MCPB Item No.: Date: 11-15-18

WMAL Bethesda, Site Plan No. 820170170

Description

Figure 13: Approximate location of natural surface trail

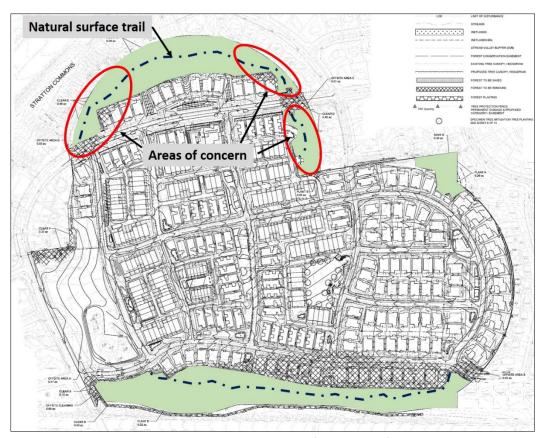
Community Concern: Neighbors argue that the placement of the walking path line should be on the "inside canopy" border of the forest conservation easements to limit any disturbance/change to the natural habitat and to maintain the existing community's privacy that they have enjoyed for over 40 years.

Staff Response: The Site Plan shows a natural surface trail through the existing forest in an approximate location. This forest will be protected by a Category I Conservation Easement and the trail will be field located to minimize impacts on the forest and in consideration with topography. There are three areas where the forest is less than 100 feet deep. Neighboring residents have expressed concerns about maintaining the privacy of their backyards. At the Community's request, Staff has agreed to condition that the Applicant must work with Staff to field locate the trail in a way that considers forest preservation, topography and distance to existing residences. Special attention will be paid to ensure the privacy of residents, particularly in these three areas circled in red in Figure 13.
